## **APP-T2 - Oncoming Traffic (summary)**

The video contains various dash-cam recordings from 2023 when approaching and passing the site of the proposed junction in a northbound direction.

All references in this document that refer to "I" mean "Edmund Forrester, spokesperson for Knowle Lane Residents' Group".

## The effect of oncoming traffic

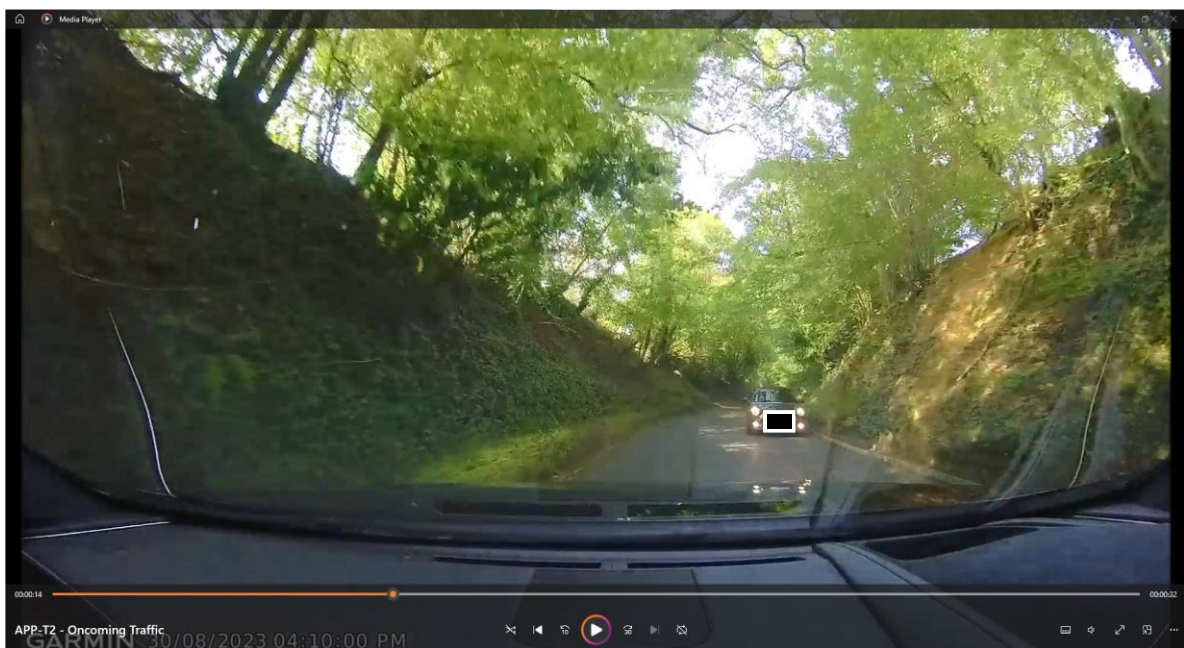
Note that these are (mostly) single vehicles. The restriction on forward visibility would obviously be more severe for multiple vehicles (both in our lane and re the junction).
